PREVOST

**WARRANTY
BULLETIN**

WB13-55A

DATE :	AUGUST 2013	SECTION :	05 - Cooling
EXPIRATION:	AUGUST 2015		
SUBJECT :	WELD INSPECTION ON TRIPOD FAN SUPPORT

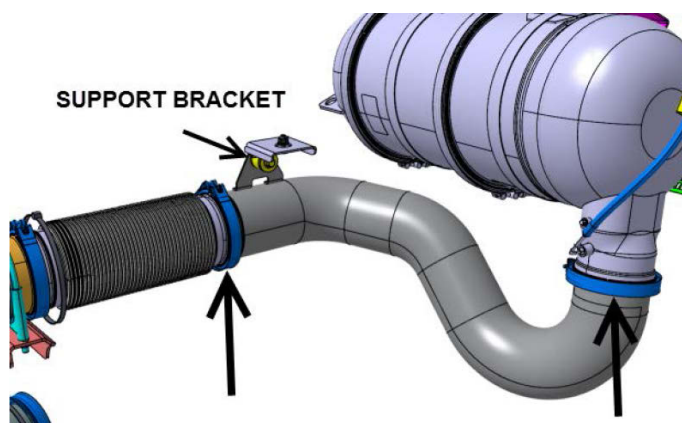
3. **H3 VIP MOTORHOMES.** The section of the exhaust pipe located between the DPF and the flexible section above the turbo must be removed to gain access to the tripod upper support.

a. Clear the two (2) V-band clamps hidden under the insulating blanket at the junction with the DPF and at the junction with the exhaust flexible section.

b. Undo the two (2) V-band clamps identified on the image.

c. Unscrew the nut at the support bracket.

d. Remove this section of exhaust pipe.

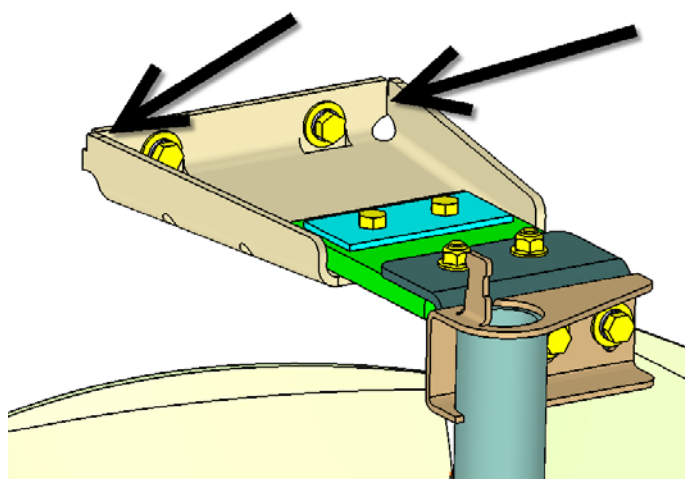
4. Use a telescopic mirror to inspect the support.

5. If there is no weld at the indicated locations, replace 053024.

MEASURE:

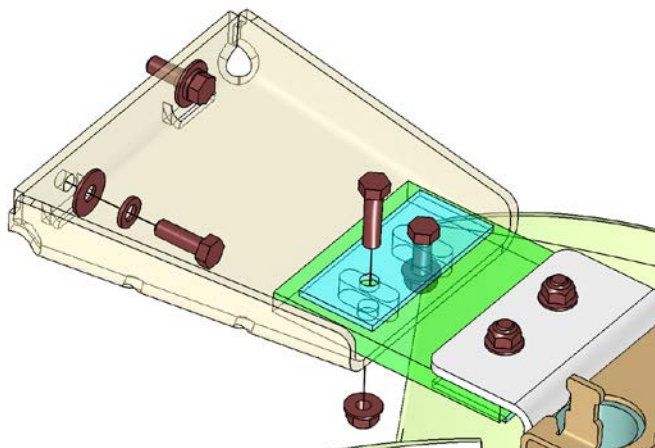
6. Choose and mark one fan blade. Measure and write down distance between edge of fan shroud and tip of blade.

This measure will be used to reposition the fan correctly.

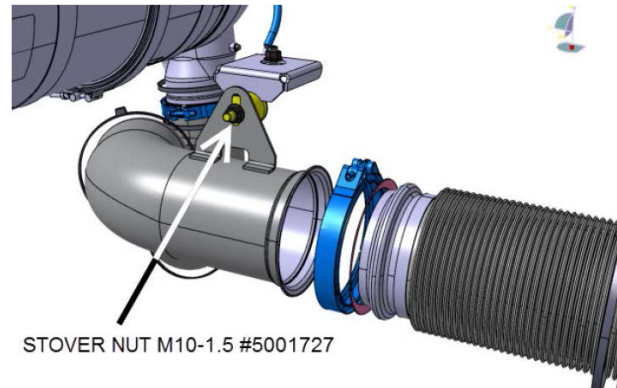
7. Remove defective support and discard. Reserve hardware for re-use. Replace any hardware missing, corroded or damaged.
8. Install new #053024 part and make sure fan returns to original position by placing fan blade tip to the measurement taken previously.

RADIATOR SIDE HARDWARE:

5001745 SCREW M8 G8.8 QTY 2

(torque 16 lbf-ft)

500942 LOCK WASHER QTY 2

500332 FLAT WASHER QTY 2

FLEXIBLE LINK HARDWARE:

5001738 SCREW QTY 2

502837 STOVER NUT QTY 2

CABLE SUPPORT

504637 TIE CABLE QTY 2

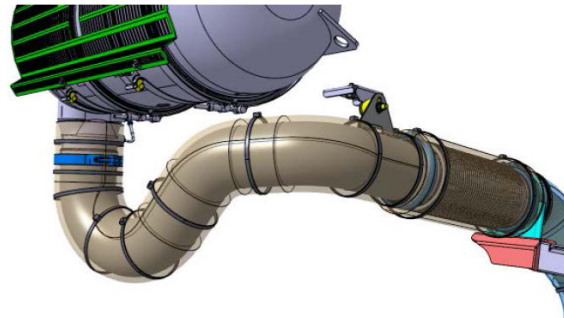
10. **H3 VIP MOTORHOMES..** Start the engine and check for exhaust leaks.

11. **H3 VIP MOTORHOMES..** Cover the V-band clamps with insulating blanket. Use nylon ties to secure the insulating blanket.
